# TC1/TC2 Return Loss Spec

# Comment 53: Need to determine the Return Loss Mask

# Reference case: ODVA Mask for 40 nodes

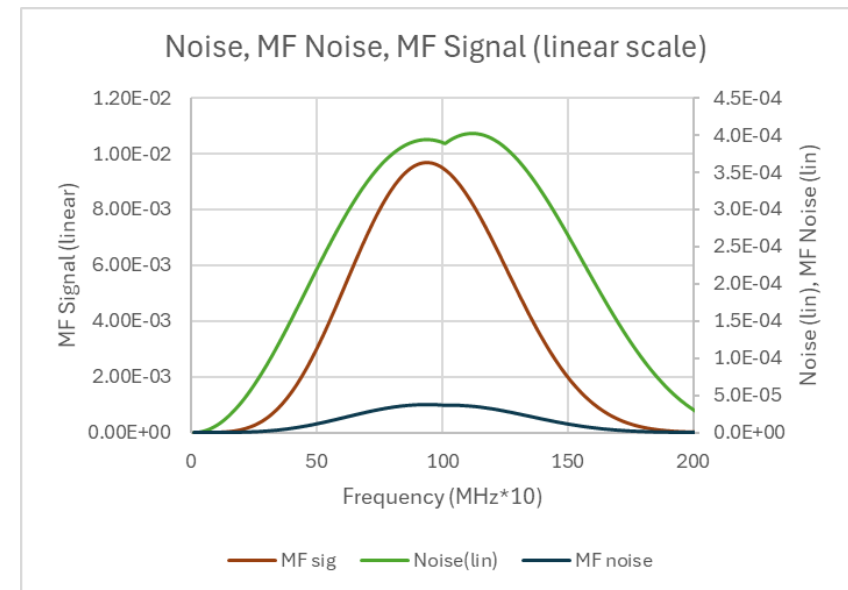
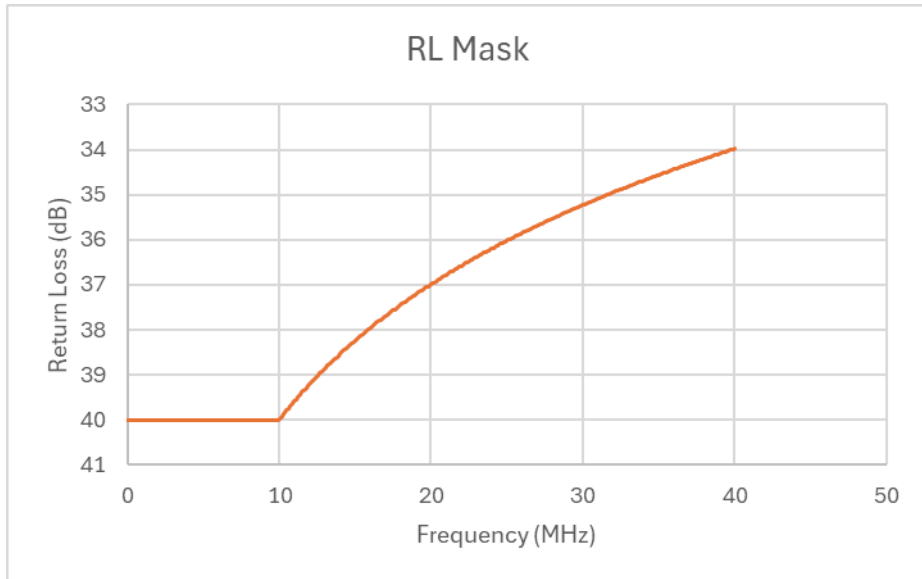
Ref: mask in brandt\_3da\_01\_0324.pdf - gives 23.6 dB MF SNR at 40 nodes

~10 dB margin

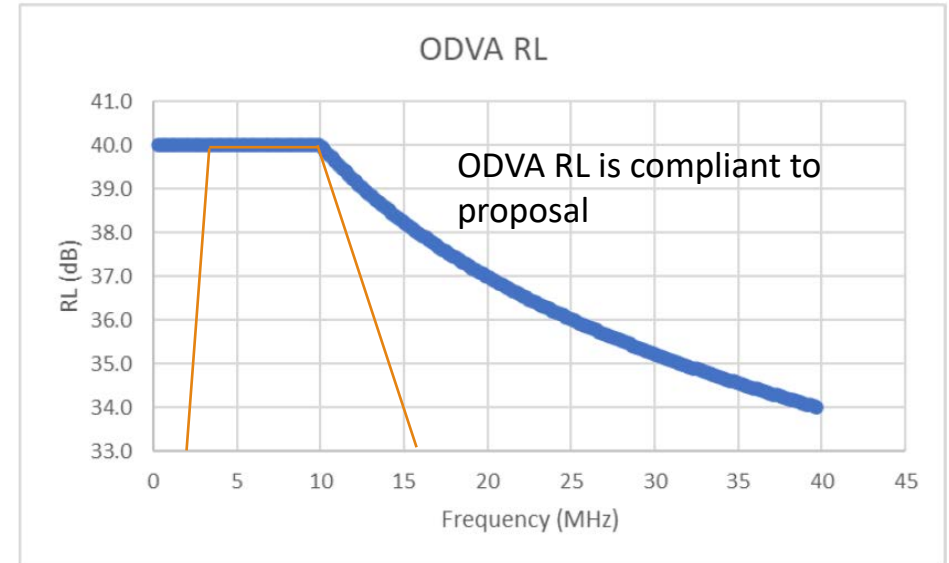
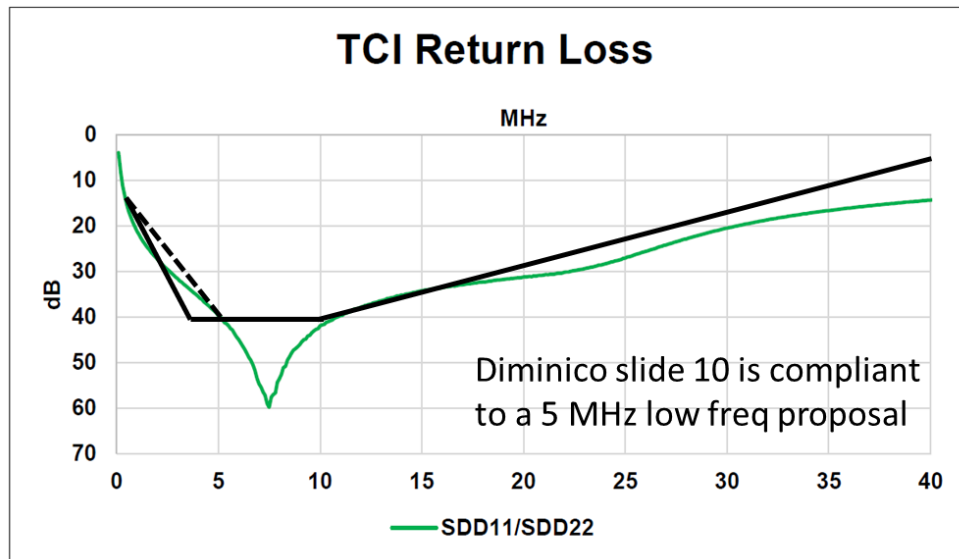
- Increasing lower frequency 40 dB floor start to 5 MHz results in ~0.9 dB SNR loss at 32 nodes relative to reference case (40 node ODVA)
  - 1.8 dB loss at 40 nodes, still > 8 dB margin
  - 3 MHz floor corner reduces loss to ~0.3 dB at 32 nodes, 1.3 dB at 40 nodes
- Fits Schreiner measurements, and allows for mismatch

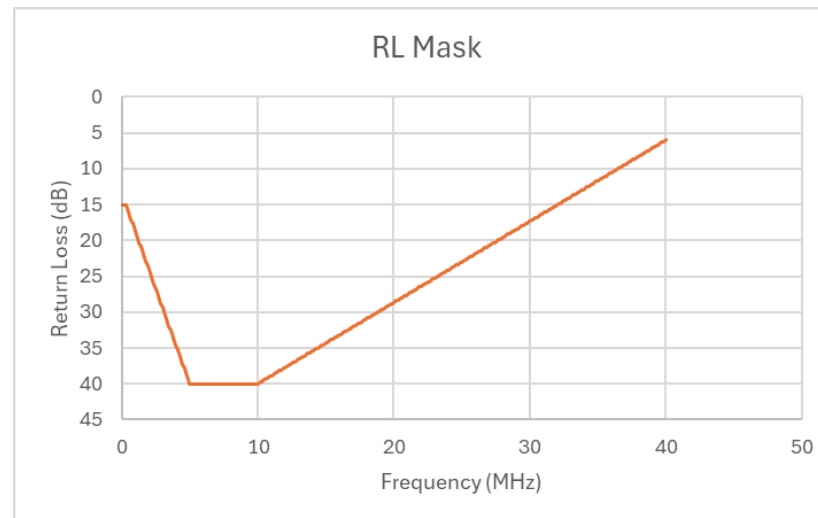
Replace TCI return loss (equation 168-5):

$$\begin{aligned}
 \text{RL}(f) \geq & \quad 15 + (f-0.3) * (25/4.7) \text{ dB} && \text{for } 0.3 \text{ MHz} \leq f < 5 \text{ MHz} \\
 & \quad 40 \text{ dB} && \text{for } 5 \text{ MHz} \leq f < 10 \text{ MHz} \\
 & \quad 40 - (f-10) * (34/30) \text{ dB} && \text{for } 10 \text{ MHz} \leq f < 40 \text{ MHz}
 \end{aligned}$$
